August 5, 2020

Product Change Notice - Solera® Awning Shield attachment

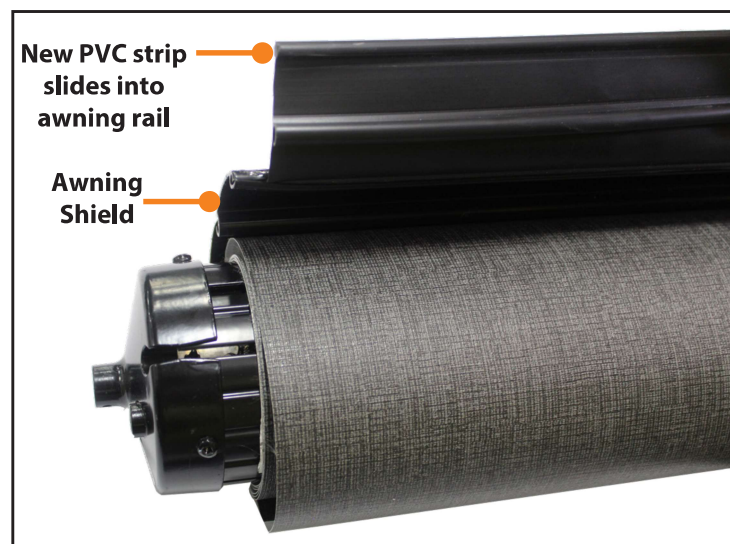
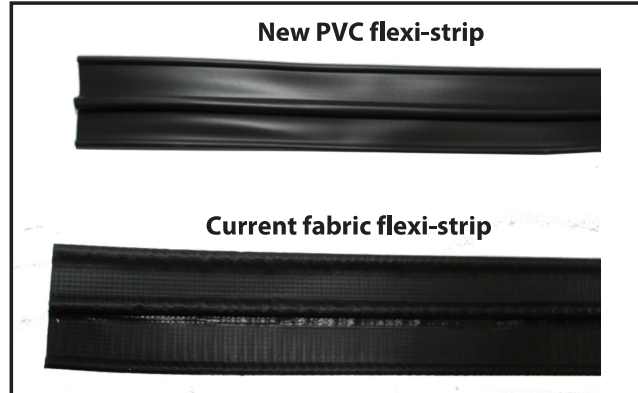
Please be advised LCI intends to change the flexi-strip on the Solera Awning Shield from fabric to PVC.

There is no change for the customer in fit, function or installation. The PVC flexi-strip slides into the awning rail on the unit in the same way as the fabric strip with polycords. The PVC piece also attaches to the awning shield in the same manner as the current fabric piece.

The change was made as an internal production improvement to eliminate the need for welding and folding the fabric piece on two separate polycords.

The part number for the current fabric piece is 676241 and the part number for the new PVC piece is 2020129277.
